ADDENDUM #1

- A. Project Number: 2023-10835
- B. Project Title: Fleck Fuel Facility Replacement
- C. Project Location: STA Valley (Fleck) Service Center, 123 S Bowdish, Spokane Valley, WA 99206
- D. Agency: Spokane Transit Authority

1.4 REVISIONS/CLARIFICATIONS TO PLANS AND SPECIFICATIONS SECTIONS

A4 TYPICAL DUCT BANK DETAIL
SCALE: NONE

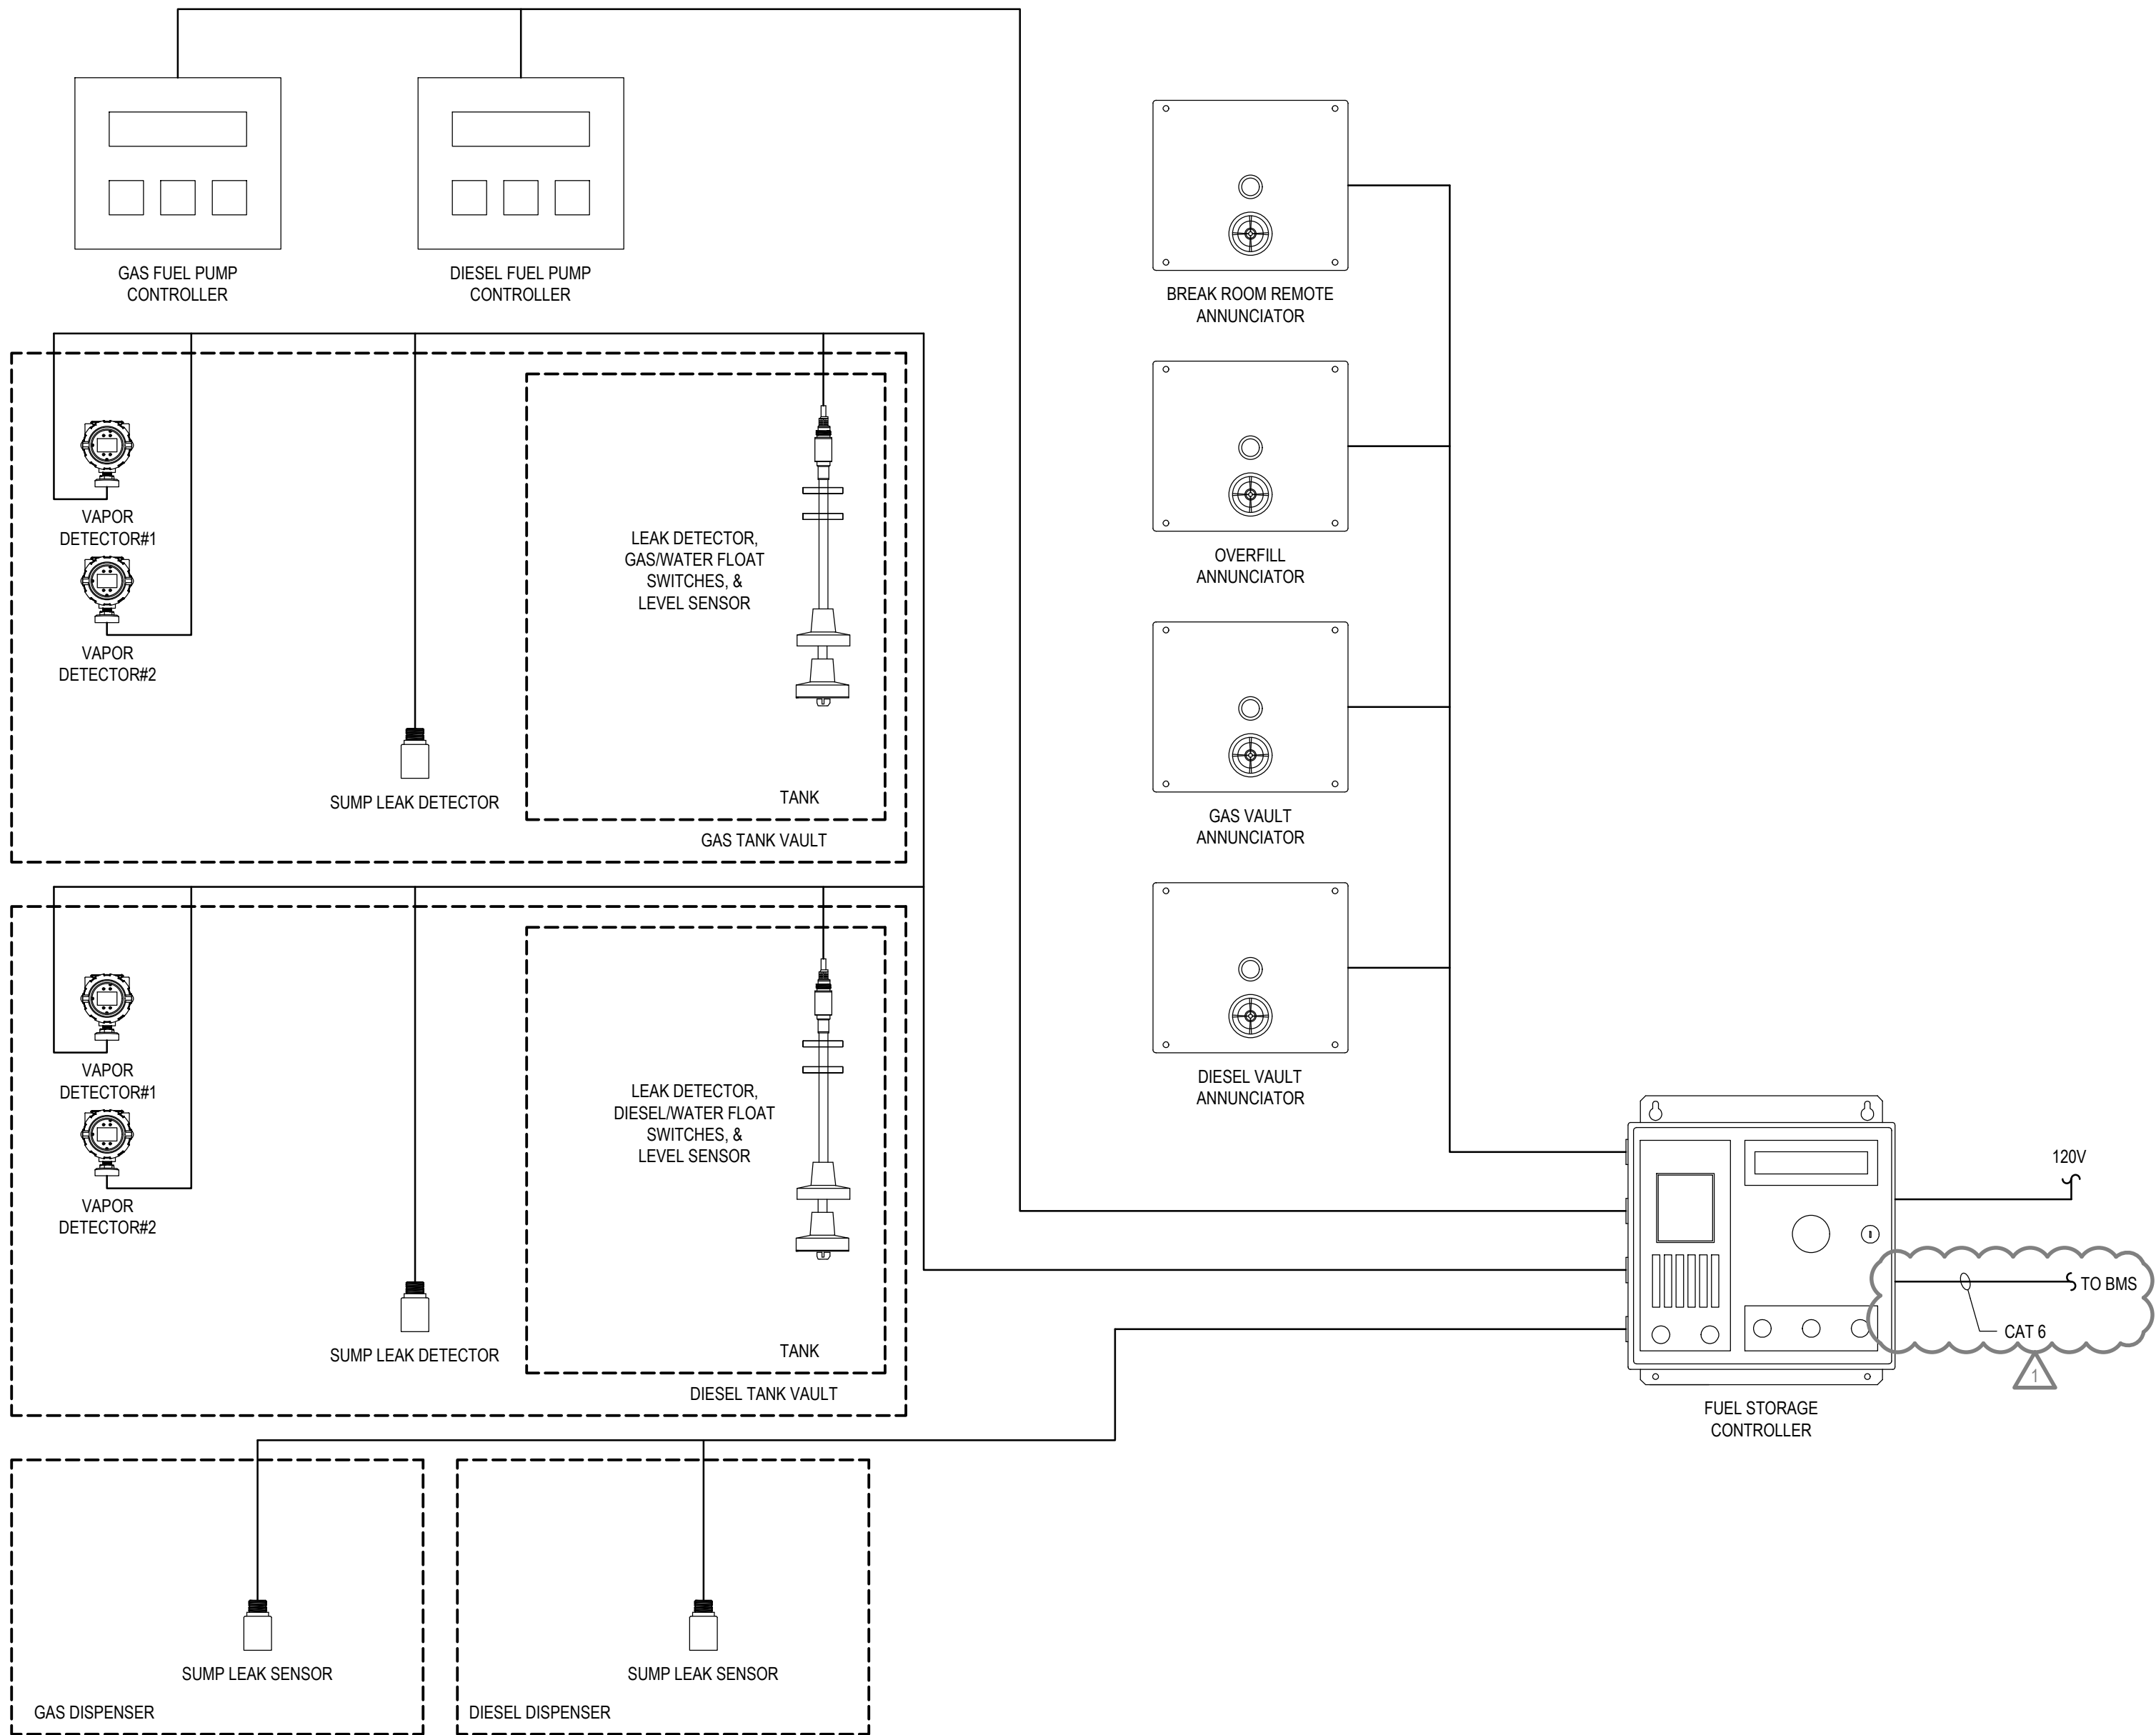
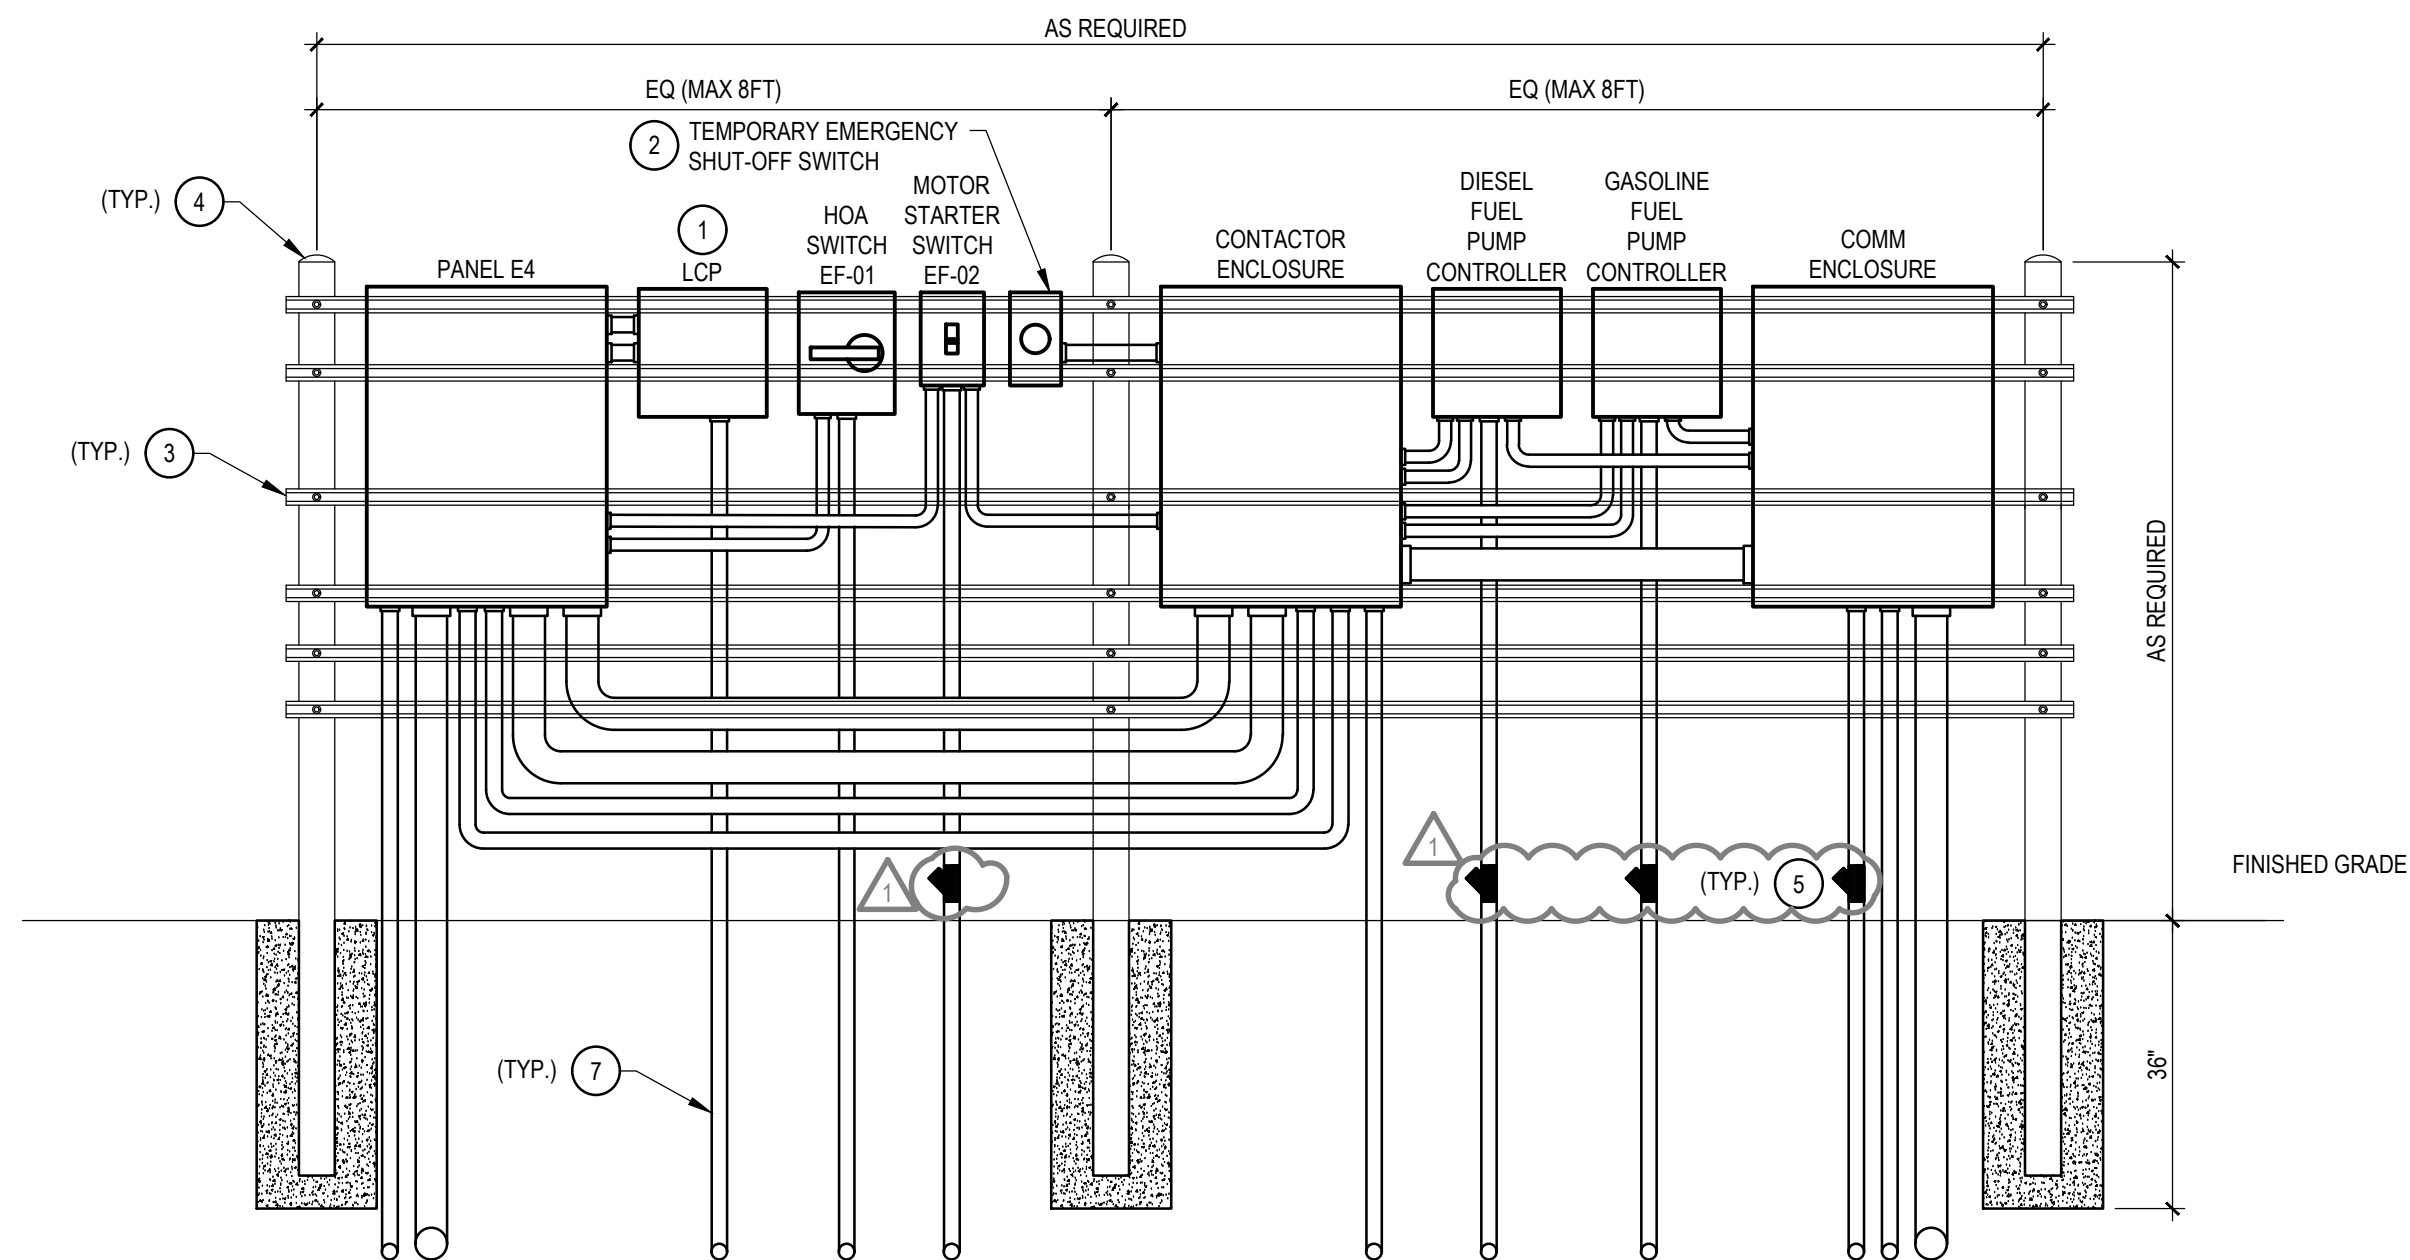
Sheet E-501 –
Added code required convenience receptacle near exhaust fans.
Removed concrete encasement from duct bank detail.
General note and drawing changes for clarification.

Question 10: *Is the electrical crossing in a concrete duct bank?*

Answer 10: This is not required and has been removed. Please refer to the revision to detail A4 on sheet E-501 attached to this addendum.
